Wednesday, 10/31/2007 3:26:10 PM Date: User: Kim Johnston **Process Sheet** Drawing Name: FORWARD CAP Customer: CU-DAR001 Dart Helicopters Services Job Number: 35475 Part Number: D2647 Job Number: Seq. #: Description: Machine Or Operation: INSPECT WORK TO CURRENT STEP QC5 Comment: INSPECT WORK TO CURRENT STEP PACKAGING 1 PACKAGING RESOURCE #1 Comment: PACKAGING RESOURCE #1 Identify and Stock Location: 8.0 Comment: FINAL INSPECTION/W/O RELEASE Job Completion U 87-11-07

```
Re D2647 Cap.txt
From: David Shepherd [davids@dartaero.com]
Sent: December 15, 2005 3:25 PM
To: Chris Provencal
Subject: Re: D2647 Cap
As long as the nutplate fits through, I think they are good. I would accept
them.
FYI, I never got this because my email never got changed to
dshepherd@dartaero.com.
David
---- Original Message ----
From: "Chris Provencal" <cpre>cprovencal@dartaero.com>
To: <davids@dartaero.com>
Sent: Thursday, December 15, 2005 1:10 PM
Subject: RE: D2647 Cap
> Any word on this?
   ----Original Message----
> From: Chris Provencal [mailto:cprovencal@dartaero.com]
> Sent: December 12, 2005 2:19 PM
> To: 'dshepherd@dartaero.com'
  Subject: D2647 Cap
> David,
> D2647 Cap, that's the front cap for the

DESIGN	DRAWN BY	DART	AEROSPACE USA, INC.
	CHECKED	APPROVED	DRAWING NO.	REV. F SHEET 1 OF 1
	DATE		TITLE	SCALE
	00.05.26		CAP	NTS
_				•

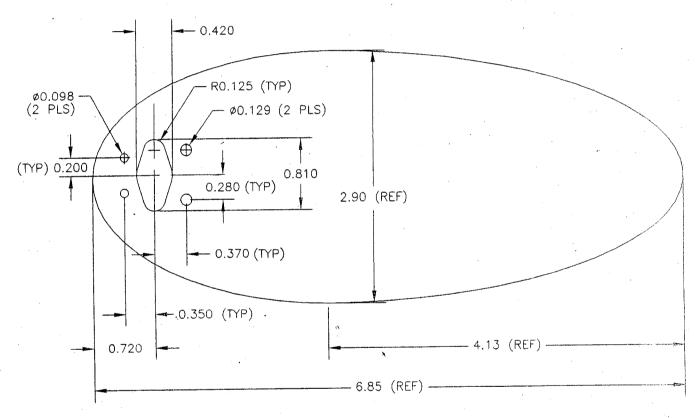
> for the width of the slot for the MS21069L4 nutplate is 0.790" for about 7

> I'm thinking they're OK, but they should check when assembling that > everything fits together OK. They can always widen the slot if need be.
